MEMORANDUM

Subject: SLUP 18-01: Archie C. Wanamaker, owner of 5419 Chamblee Dunwoody Road, Dunwoody, GA 30338, seeks the following Special Land Use Permits from Chapter 27: 1.) Sec. 27-97(e)(1)(e) to allow for steel headers; 2.) Sec. 27-97(e)(2)(a) to allow for a flat roof; 3.) Sec. 27-97(e)(2)(b) to use a light colored roofing material; 4.) Sec. 27-97(e)(2)(e) to remove any roof projects; 5.) Sec. 27-97(e)(4)(a) to allow black framed all glass doors; 6.) Sec. 27-97(e)(4)(d) to allow square window sections; 7.) Sec. 27-97(e)(4)(f) to allow for non-double hung windows; 8.) Sec. 27-97(e)(4)(g) to allow for square window panes; 9.) Sec. 27-97(e)(4)(h) to remove requirements for shutters; 10.) Sec. 27-97(e)(4)(i) to allow for the use of steel channel headers; 11.) Sec. 27-97(e)(4)(j) to allow for windows to be less than 20 inches above grade; and 12.) Sec. 27-97(l)(1) to allow for the removal of the landscape island along on the mitered corner of the building per the conditioned site plan (SLUP 16-101); The tax parcel number is 18 366 05 009.

LANDSCAPE
PLAN
L-1

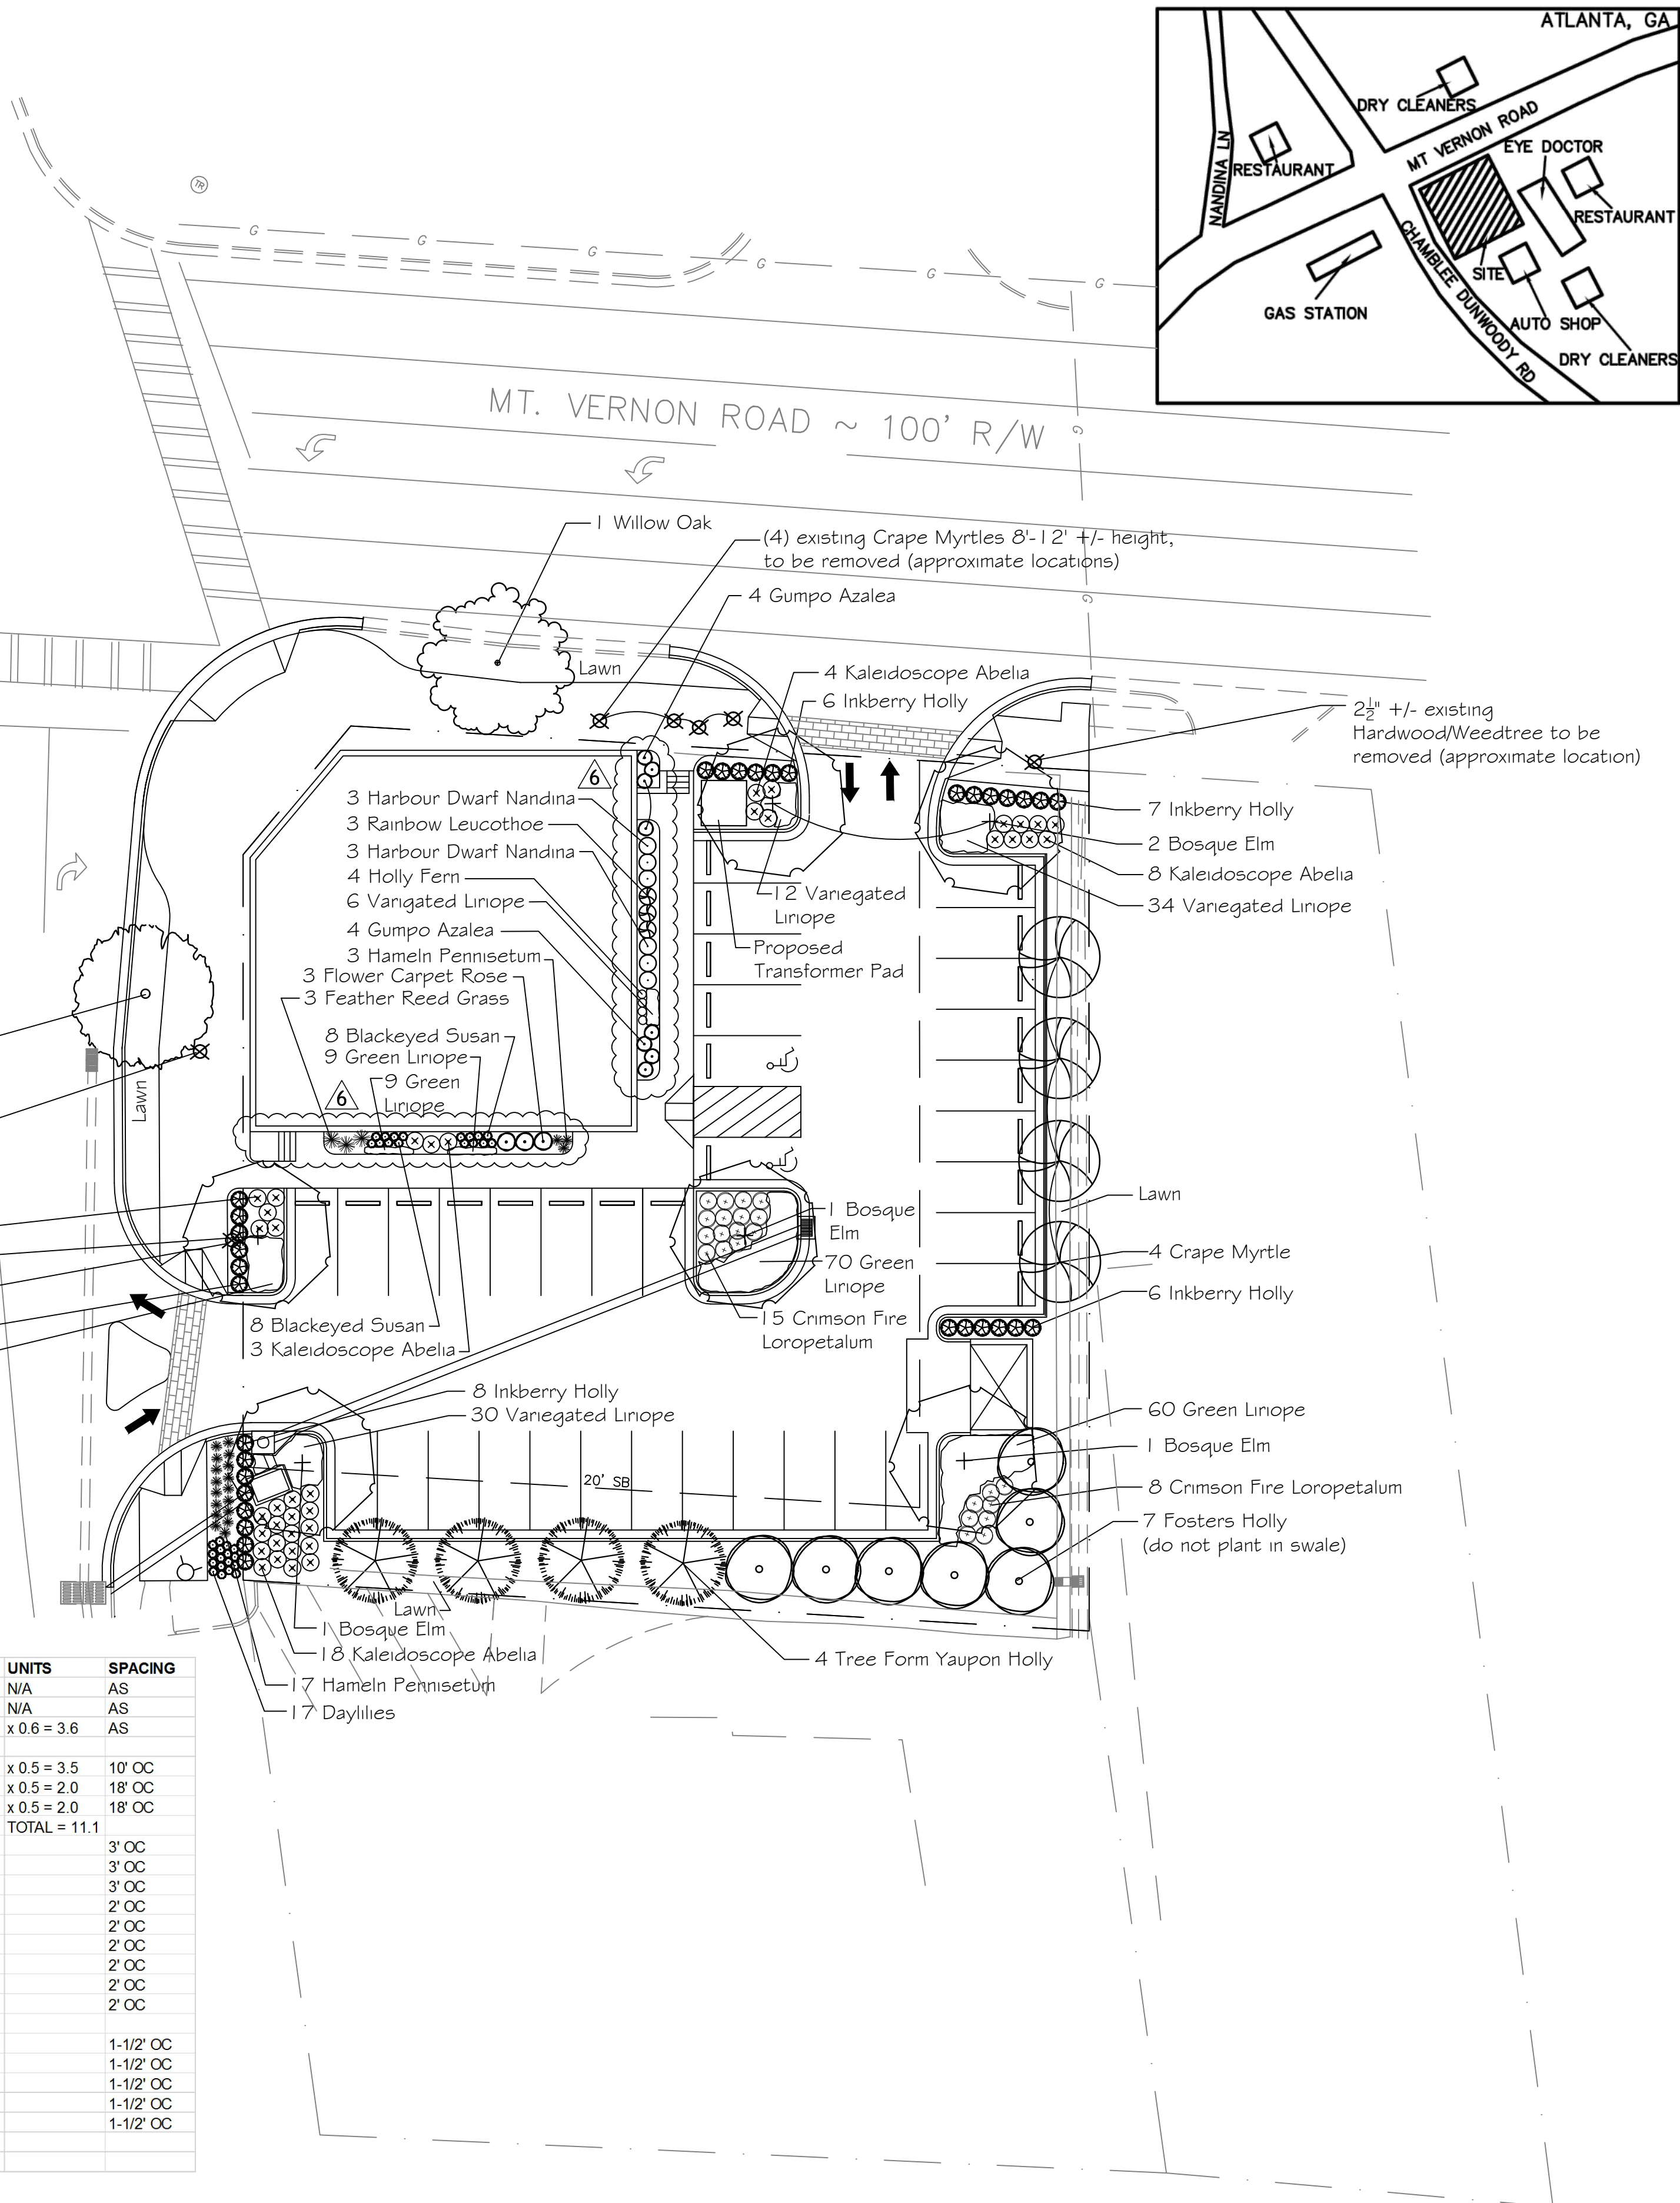
EXHIBIT B: Landscape Plan, completed by completed by SDG Engineering, dated revised June 27, 2018

1. The subject property shall be developed in general conformity with Exhibit A and B above, with changes to meet land development and zoning regulations.

PROPOSED WEST (CHAMBLEE-DUNWOODY RD.) ELEVATION- 5419 CHAMBLEE-DUNWOODY ROAD.
3/16"=1'-0"

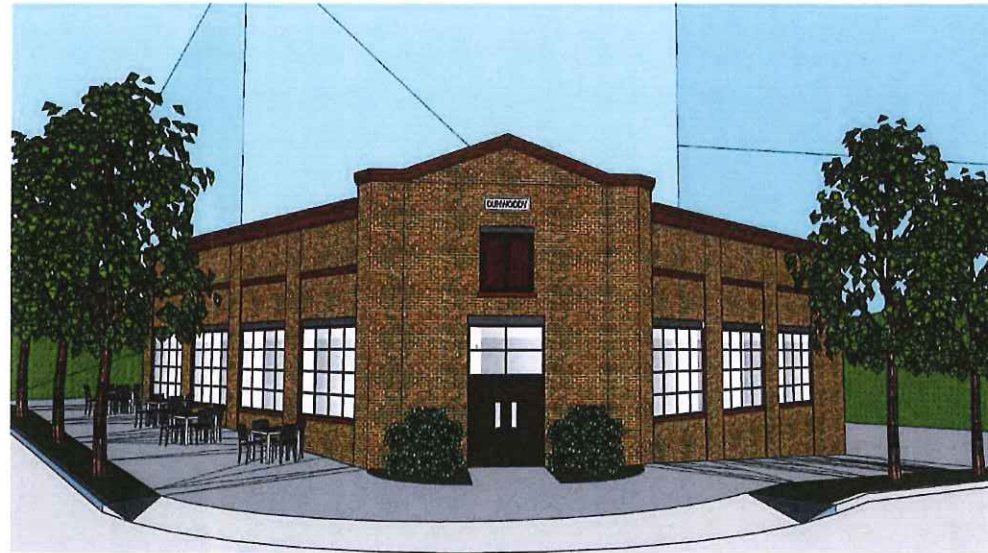
3. The front entrance, along the mitered section of the building, shall provide window and awning treatments, conducive to the industrial style as approved by the Director of Community Development.

4. The cornice shall provide brick architectural detailing as approved by the Director of Community Development.
5. Two hard wood street trees shall be planted in the right-of-way at each street frontage.
